TOWN OF PLAINFIELD

MEMORANDUM

TO: Design Review Committee
FROM: Planning and Zoning
DATE: October 5, 2021
RE: Encore PUD Ordinance Text and Final Development Plan Amendment

New Exhibit C

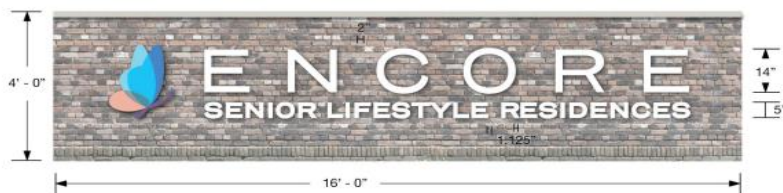
- Applicant needs to address why there is nowhere on site that can accommodate the proposed monument sign. How was this missed?
- Applicant needs to address how this vertical urban style sign fits the suburban/rural architecture of this building.
- Applicant needs to address verticality -v- horizontal wall signage.
- Applicant needs to address the verticality of this sign spans two exterior finish materials and how that is to blend and not be a distraction to the overall envelope of the building's architecture.
- Applicant needs to explain in detail the benefits of an internally illuminated wall sign with routed aluminum face and 3/4" push through letters; the logo panels are to be vinyl prints (with no dimensionality).
- Applicant needs to address selected location of address numbers and proximity to wall sign. Would a more elegant location be within opening of entrance canopy?
